**TO: PLANHOLDERS**

**SUBJECT: PIER 4 PHASE 2 RECONFIGURATION**  
PROJECT NO. 091251  
CONTRACT NO. 070136

### **ADDENDUM NUMBER FIVE**

**D SHEET PILE SECTION**  
1"=1'-0"

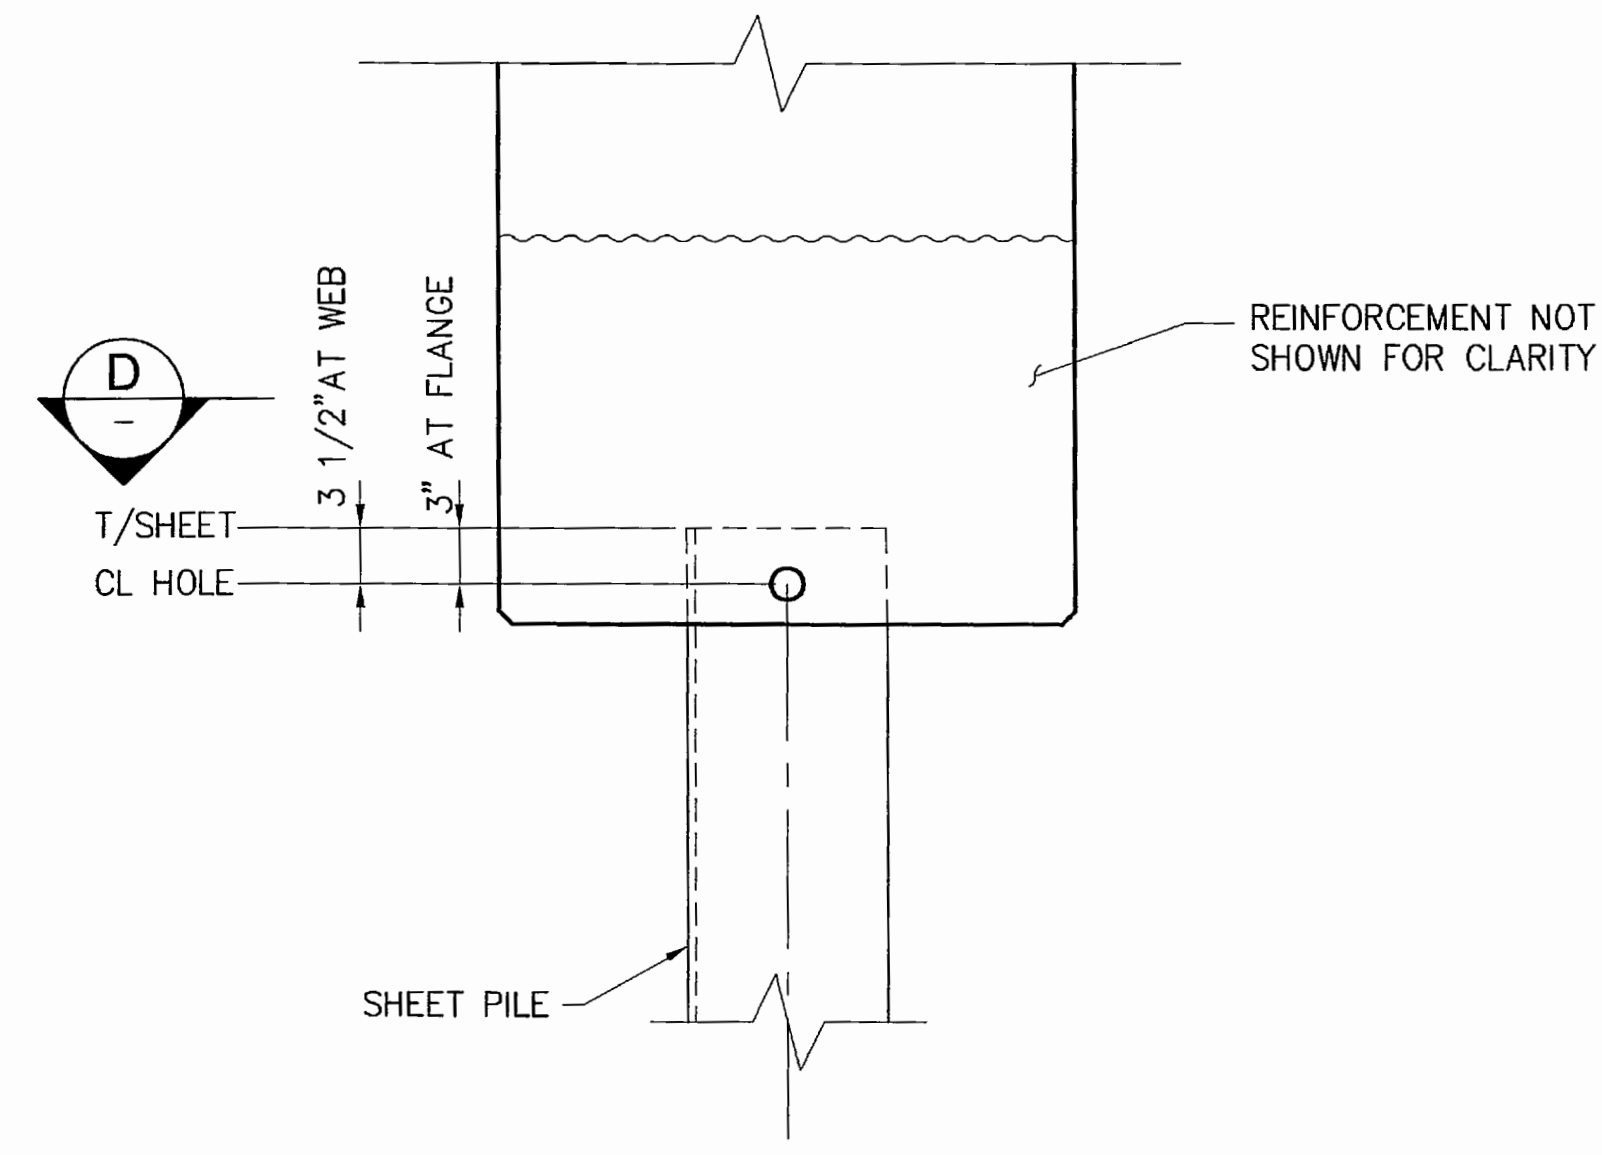
1. **REVISE** Detail D Sheet Pile Section as denoted. (See Attachment D to this Addendum No. 05).

**ATTACHMENT E - DRAWING S14.1 – STEEL SHEET PILE DETAILS (SHEET 379)**

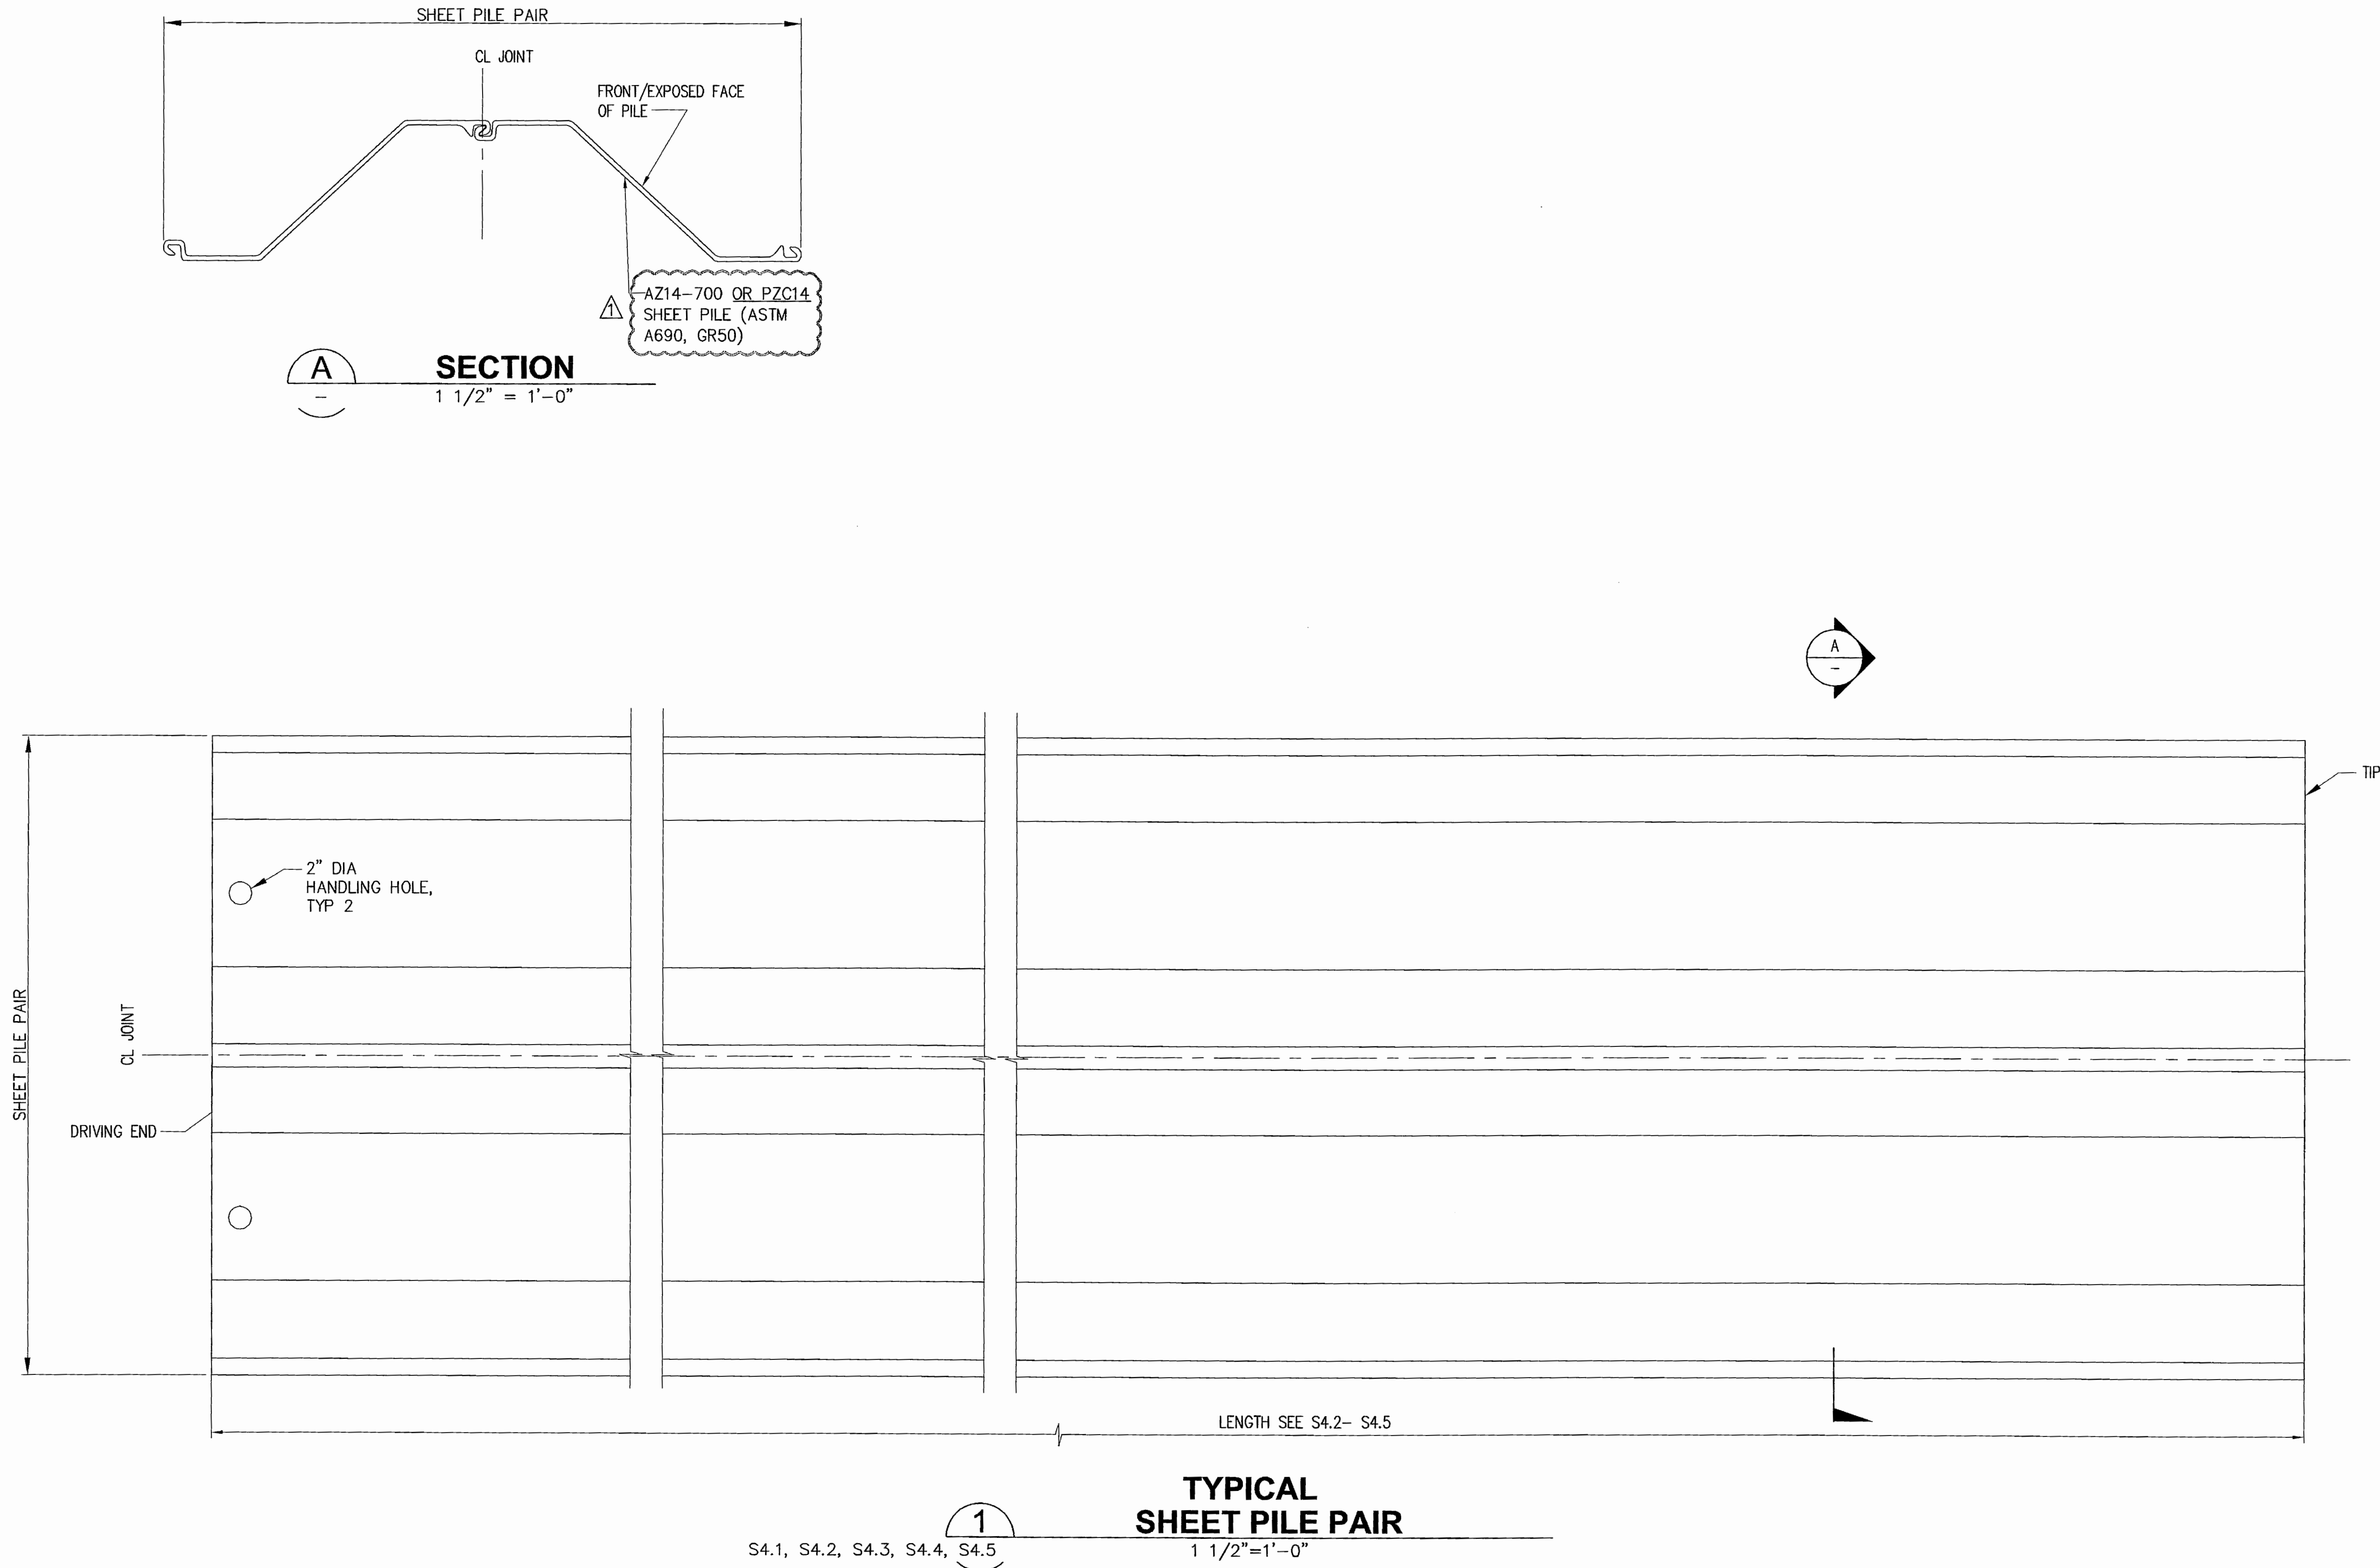
1. **REVISE** Section A as denoted. (See Attachment E to this Addendum No. 05).
